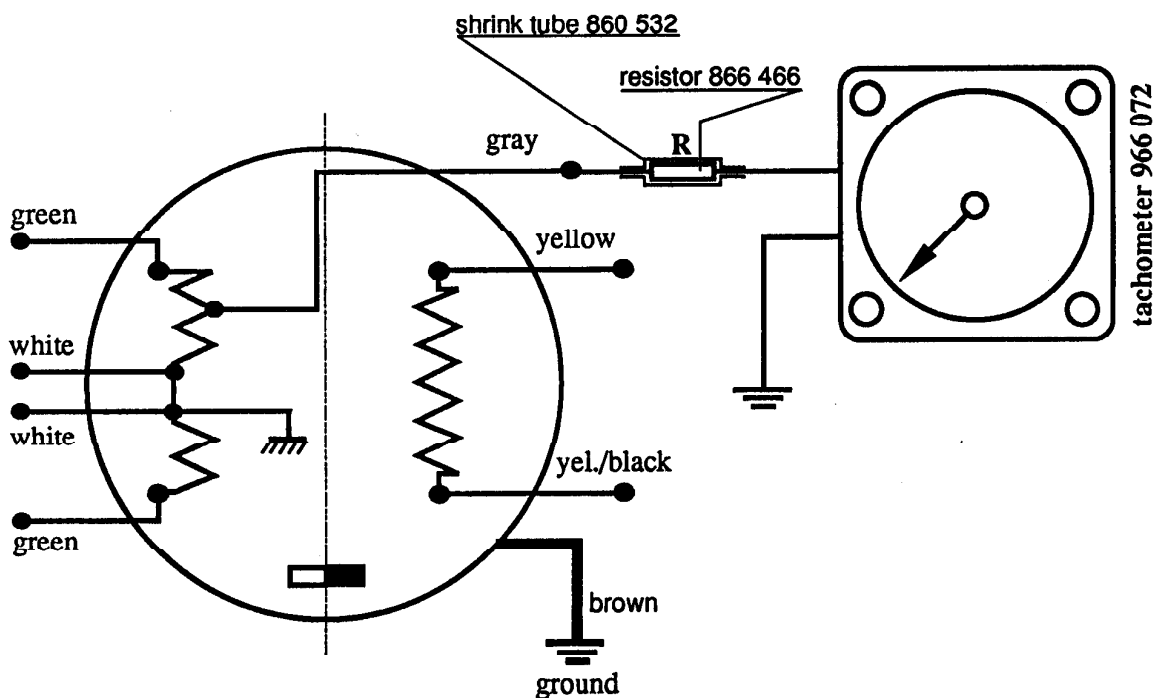
8) An external resistor of 1 k $\Omega$  (866 466) must be installed in the grey cable and protected by a shrink tube (860 532) as shown below. This resistor replaces the one in the stator and is necessary to protect the tachometer 966072.

**ATTENTION:** If the resistor 866 466 gets installed without removing the resistor from the stator (coil set), the tachometer indicates a higher r.p.m. drop when checking a single ignition circuit.

For all tachometers 966 072 supplied so far we supply 1 resistor 866 466 and shrink tube 860 532 on request.

9) If the new tachometer 966 074 (for identification, blue label on back side) is used, no resistor must be installed because already integrated in the tachometer.
